Subject: NOISE FROM BOTTOM OF A-PILLAR	Bulletin No: 09-025/16
	Last Issued: 04/19/2016

This bulletin supersedes the previously issued bulletin(s) listed below. The changes are noted below in Red beside the change bars.

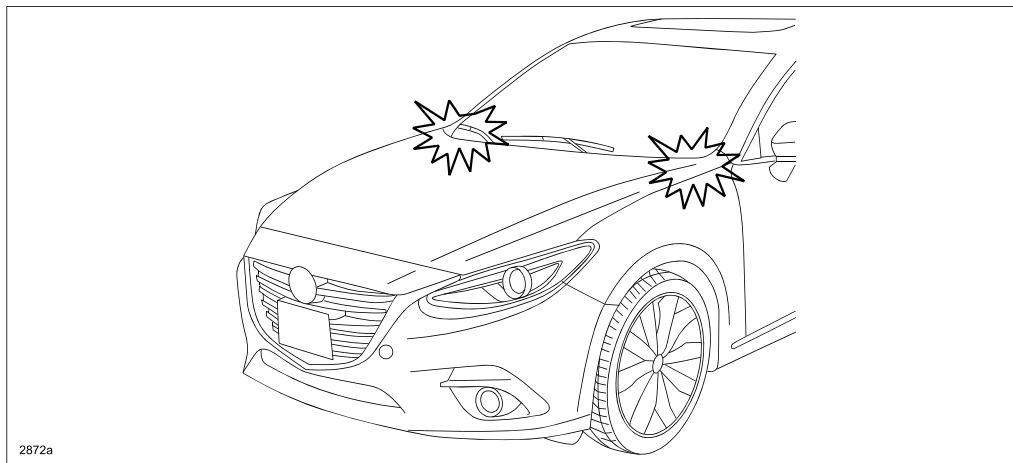
2014-15 Mazda3 (Japan built) with VINs lower than JM1BM*****230374 (produced before September 1, 2014)

2014-15 Mazda3 (Mexico built) with VINs lower than 3MZBM*****227448 (produced before May 29, 2015)

Locations to create clearance

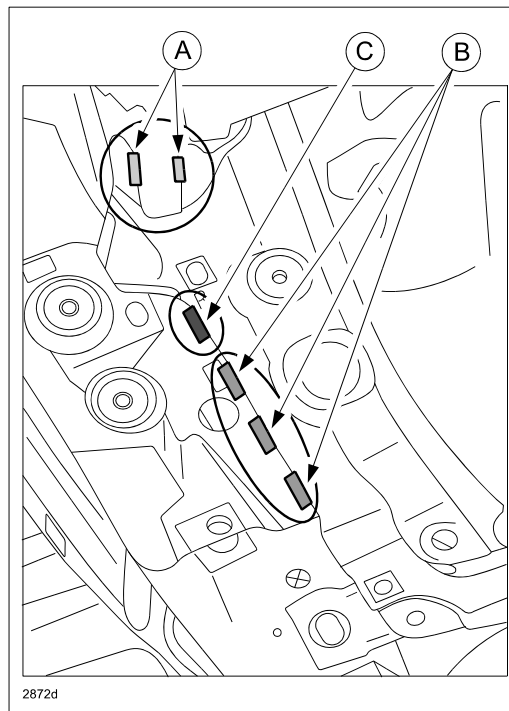
- Areas A and B: Create a clearance for all vehicles
- Area C: Create a clearance for vehicles with VIN range JM1BM*****100001 - 189735

Area C for vehicles with VIN range JM1BM*****100001 - 189735

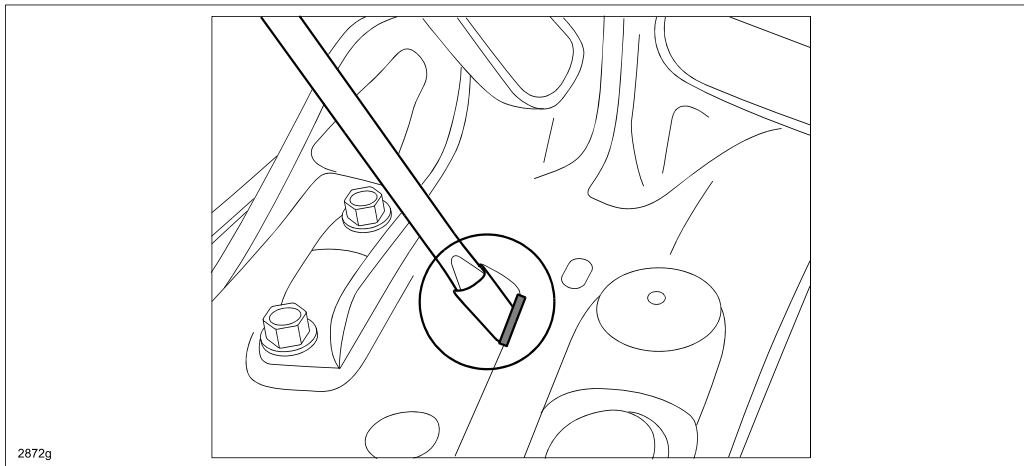
NOTE: It is not necessary to perform this repair on Mexico built veicles.
